# NACRA Sailing

Dear Nacra 15 and Nacra F16 customer,

Productive update Nacra 15 & Nacra F16 mast base to mast connection

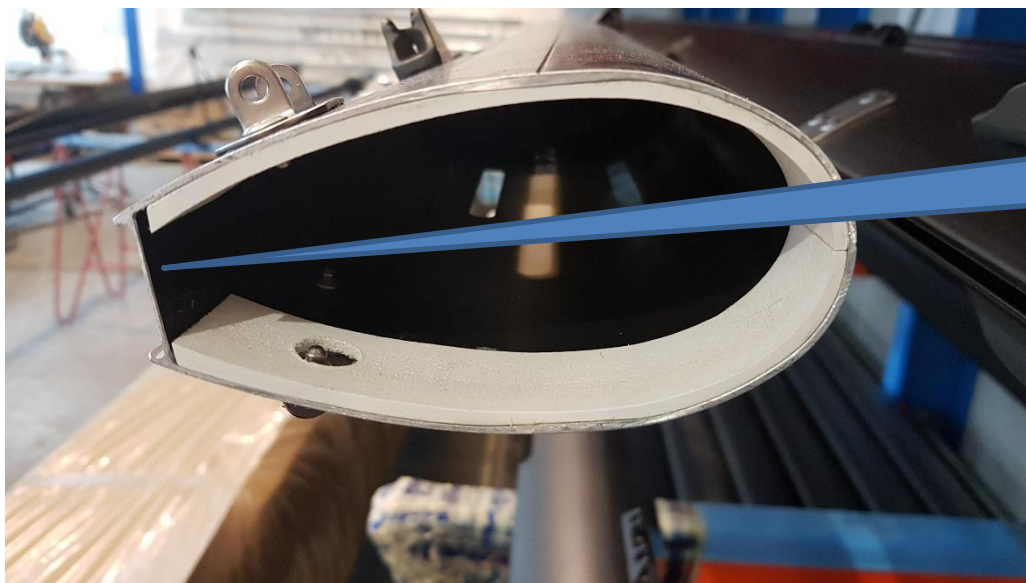
We have received reports from Nacra owners about an incorrect fit between the mast base and mast profile.

- Too much play between mast foot and mast profile.
- In some cases the mast base was able to penetrate into the mast profile.

Pictures below are from a mast that had too much play and was damaged.

Mandatory Instructions,

Please disassemble your mast base from your mast

- The mast base can be disassembled by undoing the diamond tension bolt, after the mast is taken down from the boat.
- Check if the standard installed strips are still properly glued inside the mast (see picture below)
- Instal a new 20x30x3mm strip (see instructions below)

Mast as original  
supplied

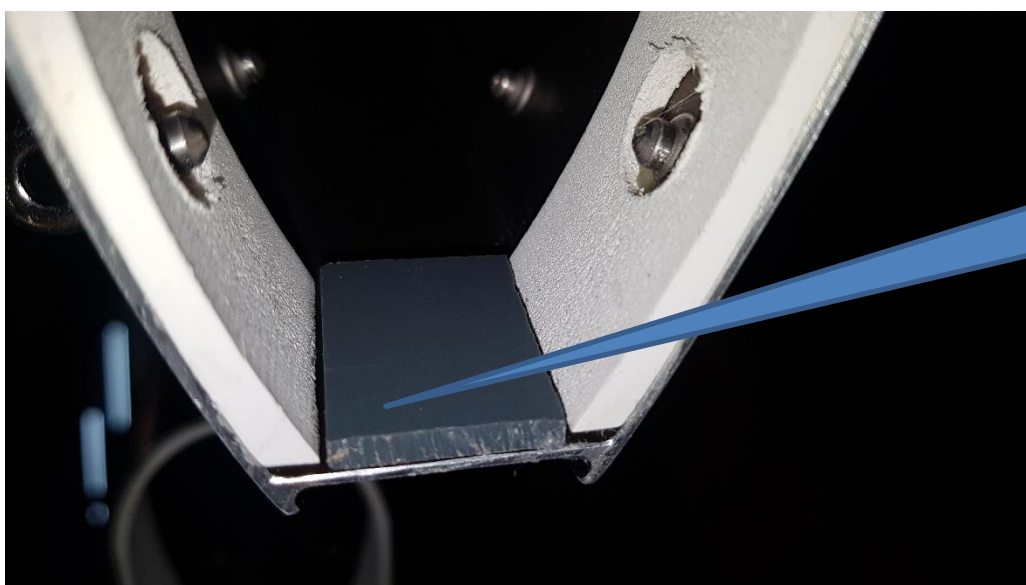
The above picture shows the original strips glued inside the mast without the new mandatory strip. Please check if the original strips are still properly glued.

New added  
strip to stop  
fore and aft  
movement

Please glue in a strip as shown in the picture above, with an epoxy base glue. Only use a strip made from a composite material with a measurement of 20x30x3mm. needed
